ISO/IEC 10373-1

AMENDMENT 1
2012-11-01

Identification cards — Test methods —

Part 1: General characteristics

Figure Amd.1-1 — ICC-holder

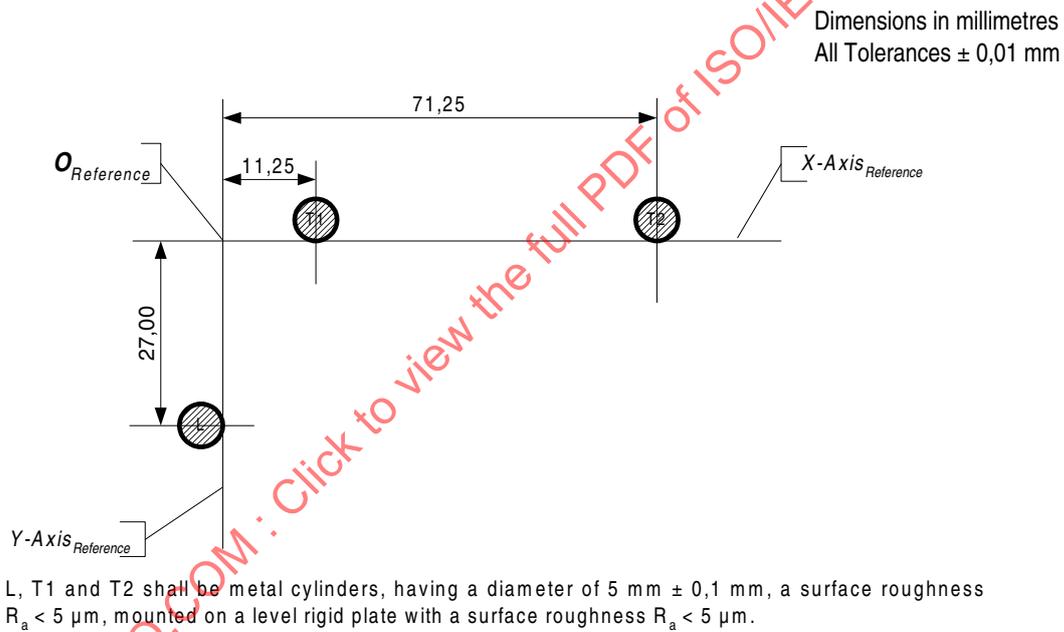
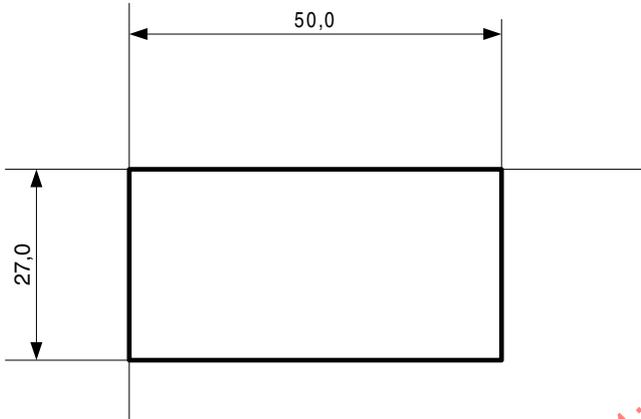
4.7.2 Default ICC-holder and reference axes:

The default ICC holder shall comply with Figure Amd.1-1:

Figure Amd.1-2 — Flattening plate

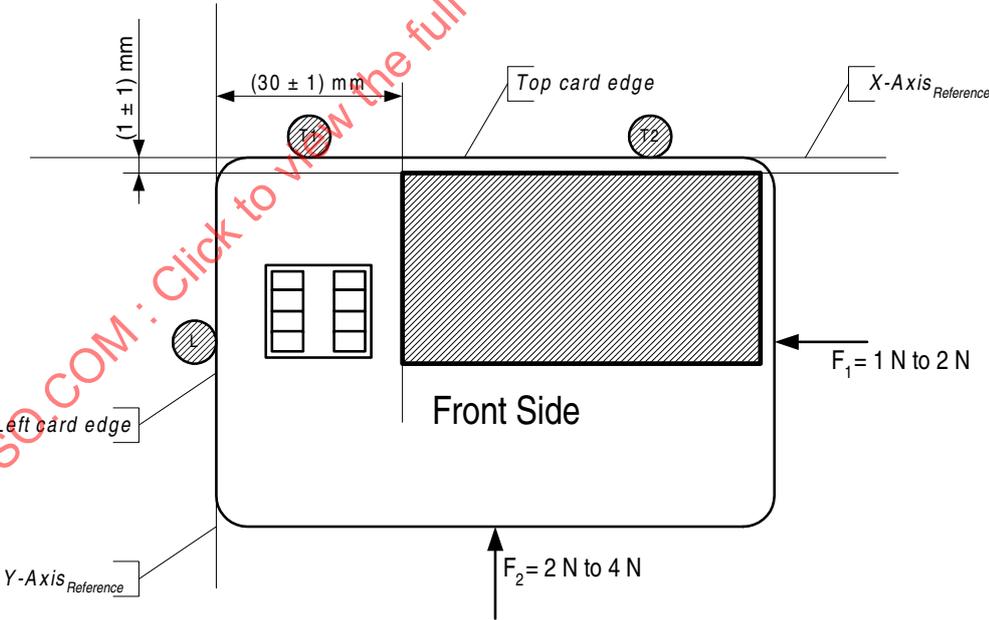
4.7.3 Flattening Plate

The flattening plate shall comply with Figure Amd.1-2:

Dimensions in mm
All Tolerances $\pm 0,1$ mm

The surface roughness of the flattening plate shall be $R_a < 5 \mu\text{m}$.

Figure Amd.1-4 — ESD test circuit

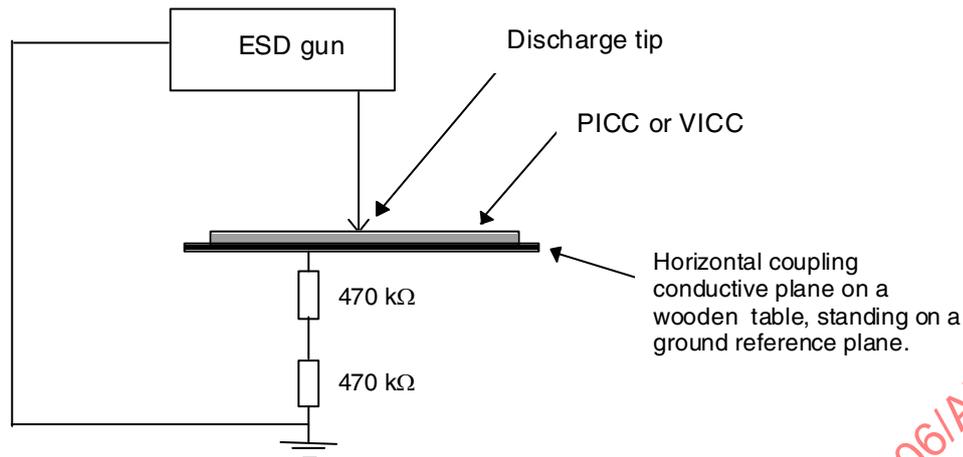
5.19 Static electricity test for proximity and vicinity ICCs

The purpose of this test is to check the behaviour of the card IC in relation to electrostatic discharge (ESD) exposure in the test sample. The PICC or VICC under test is exposed to a simulated electrostatic discharge (ESD, human body model) and its basic operation checked following the exposure.

Connect the ground pin of the apparatus to the conductive plate upon which the PICC or VIVV is placed (see Figure Amd.1-4).

Figure Amd.1-5 — Test zones on PICC or VICC for ESD test

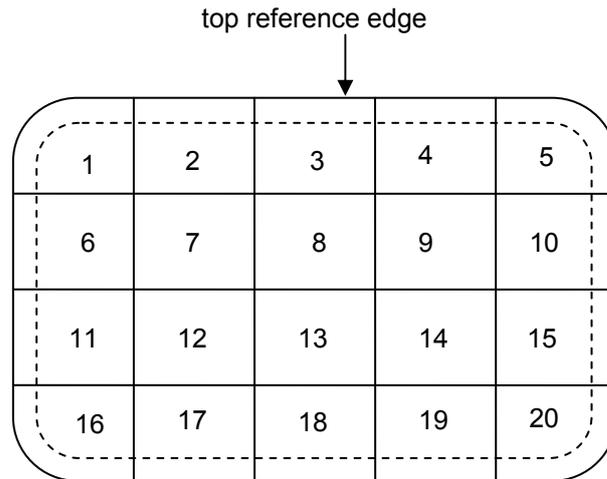
Apply the discharge successively in normal polarity to each of the 20 test zones shown in Figure Amd.1-5 ensuring that the discharge tip is not applied within 6 mm of the card perimeter (see the dashed boundary line in Figure Amd.1-5) and allowing a cool-down period between successive pulses of at least 10 s.

WARNING — If the PICC or VICC includes contacts, the contacts shall face up and the zone which includes contacts shall not be exposed to this discharge.

Figure Amd.1-6 — Test prods

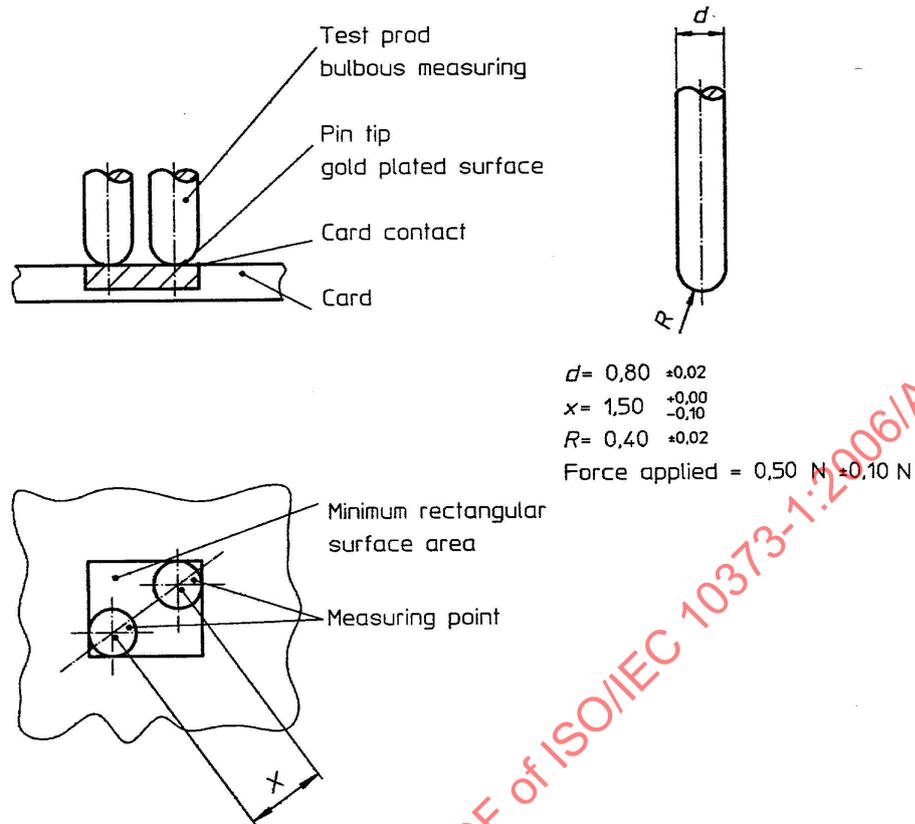
Ohmmeter with a range from 10 mΩ to 2 Ω having an accuracy of ± 2 mΩ and test prods as defined in Figure Amd.1-6. The measurement current shall be less than or equal to 100 mA and the measurement voltage shall be less than or equal to 20 mV.

Figure Amd.1-7 — Measurement tip

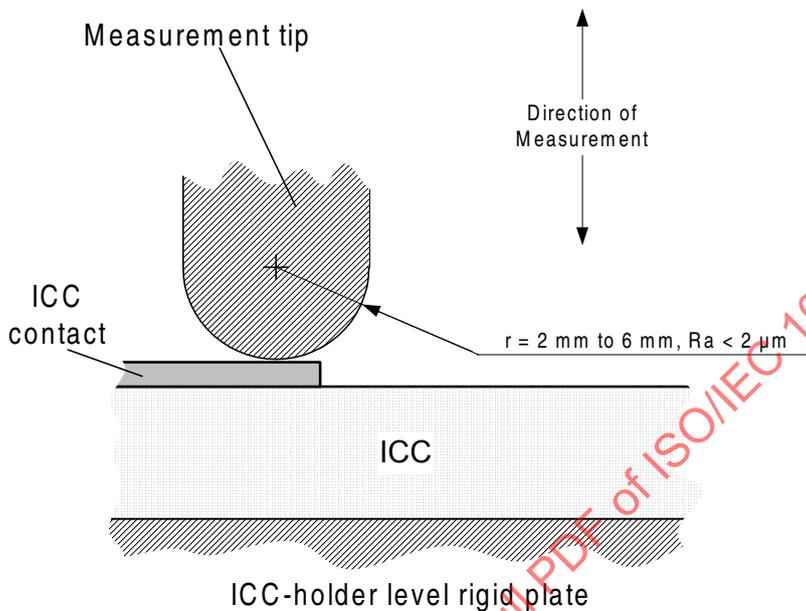
A measurement device capable of measuring the perpendicular distance between the upper surface of the level rigid plate of the ICC-holder and the upper surface of an ICC placed on the ICC-holder with an accuracy of 0,01 mm. The area of measurement shall be 2,5 mm wider in all directions than the area covered by the contact metallization of the ICC to be tested. The measurement tip shall be as shown in Figure Amd.1-7:

Figure Amd.1-8 — Measurement line across contacts C1 and C5

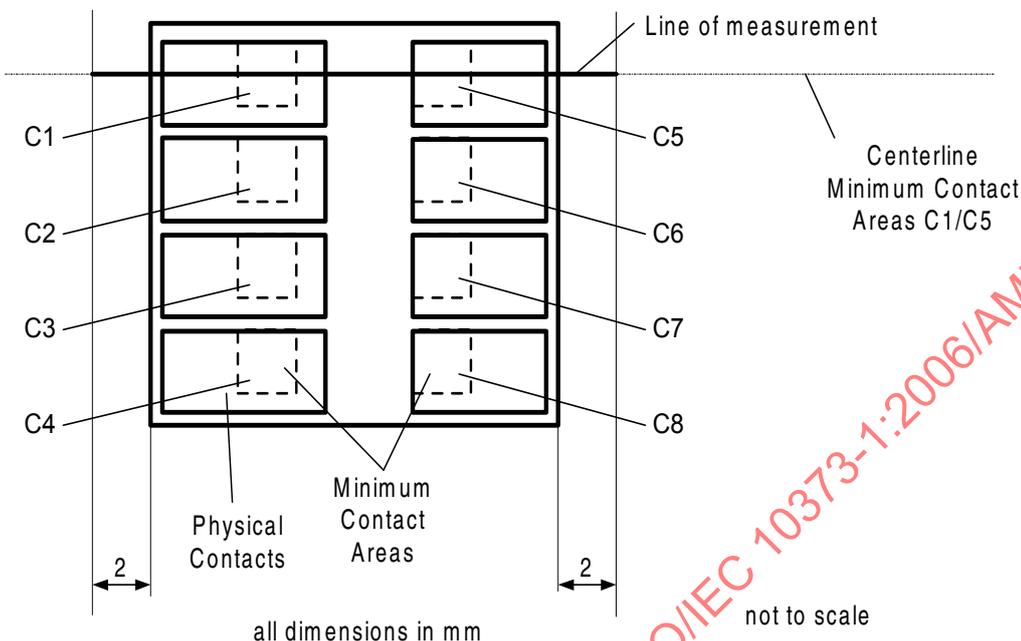
- Mount the ICC in the default measurement position as defined in 4.6.1.
- Construct a measurement line on the surface of the ICC along the centerline of the minimum contact areas C1 and C5, beginning and ending at a distance of 2 mm of the metallized contact surface (Figure Amd.1-8).

Figure Amd.1-9 — 3 wheel test principle

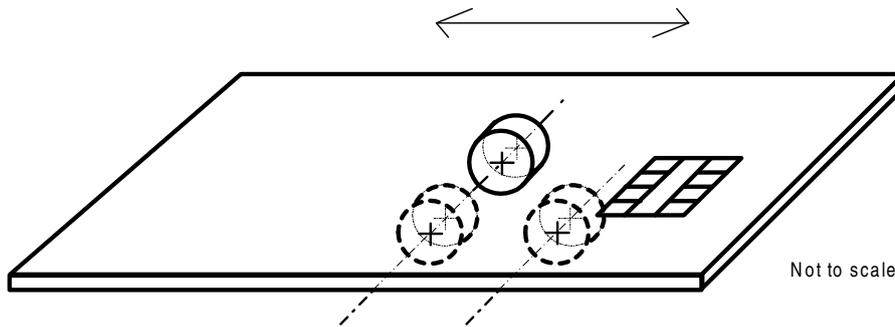
The principle of the apparatus is shown in Figure Amd.1-9. It comprises three wheels, one above and two below the ICC. The ICC is moved cyclically between the three wheels, so that the contact area is repeatedly exposed to the forces exerted by the wheels.
